Grimes Planning and Zoning Commission Agenda

Grimes Planning & Zoning Commission Meeting December 3, 2024
In Person at Grimes Community Complex, 410 SE Main Street, Room 202 at
5:30 PM

RE: Maranatha Site Plan Amendment

MARANATHA BAPTIST CHURCH - MAIN BUILDING RENOVATIONS

C3.1:

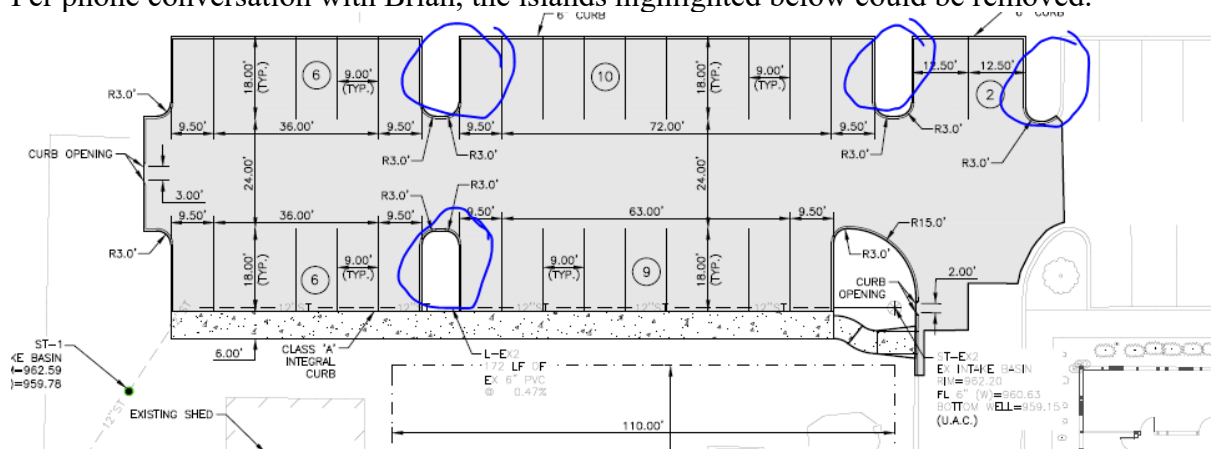
1. ~~This building is going to be required to be retrofitted with a sprinkler system given the improvements proposed. Please show where the fire sprinkler line will be run. The split is required outside of the building. Please show the split with curb stops or valve on each line. If the plans need to be updated after further analysis of the existing line, that is fine. You'll just need to provide the plan revision for review and approval.~~
2. ~~Please show frost protected landing outside the proposed lobby entrance. Grimes amendment 11-11-2 (1010.1.6.1).~~
3. ~~Add a cross ramp on the existing sidewalk and provide grading details for both ramps. Sidewalk will be added with future sanitary building construction.~~

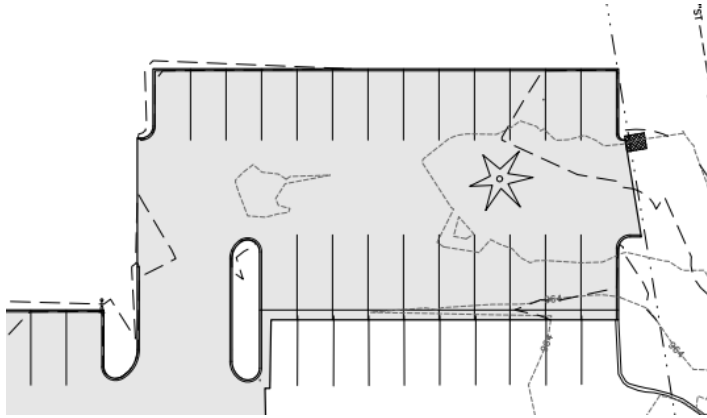
4. ~~Per phone conversation with Brian, the islands highlighted below could be removed.~~

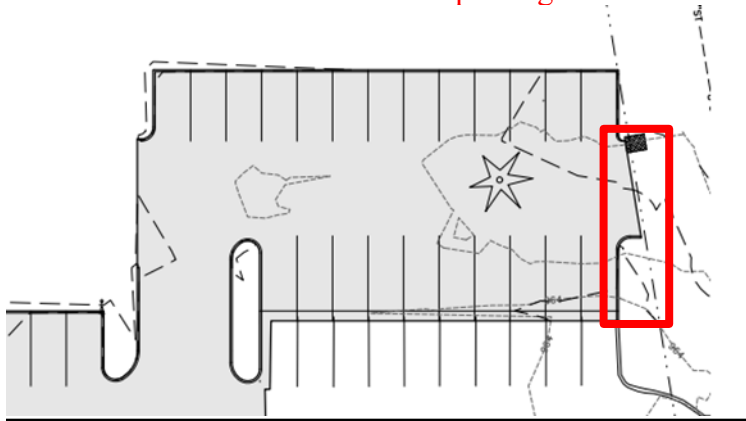
5. Remove the tree from the NE parking area.

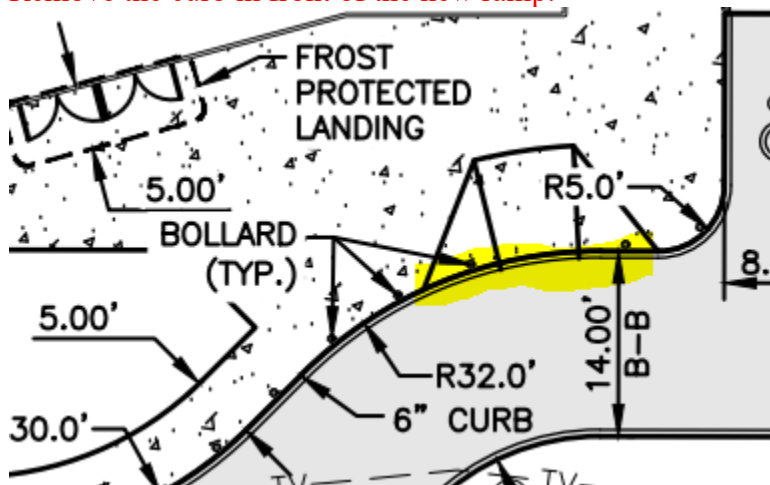
6. Provide curb at the east side of the parking area.

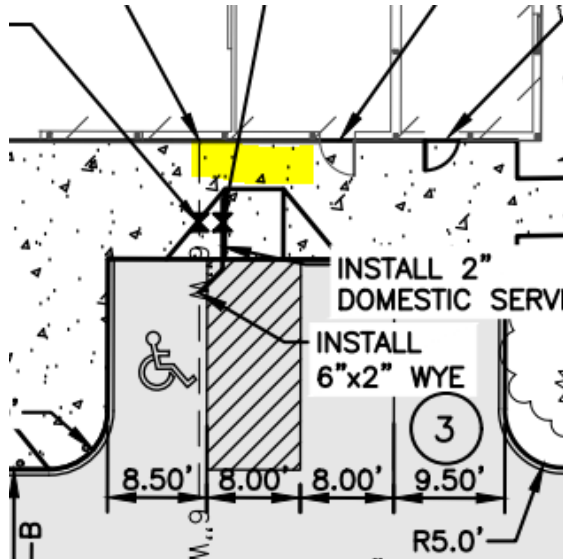
7. Remove the curb in front of the new ramp.

8. Move the water service valves out of the ADA ramp.

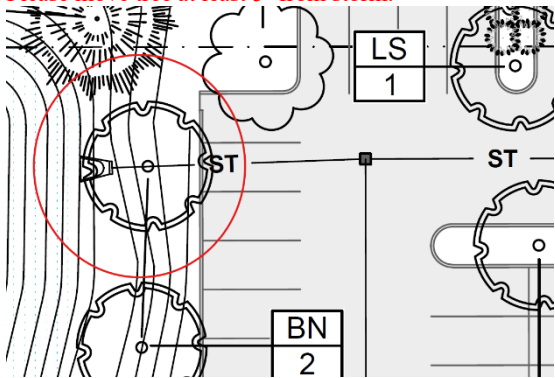
16. Please correct and confirm the number. The correct quantity is reflected in the plant schedule.

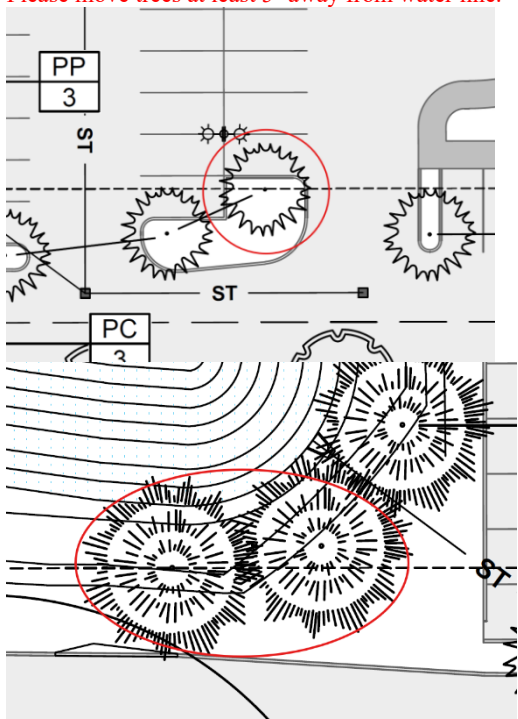
17. Please move tree at least 5' from storm.
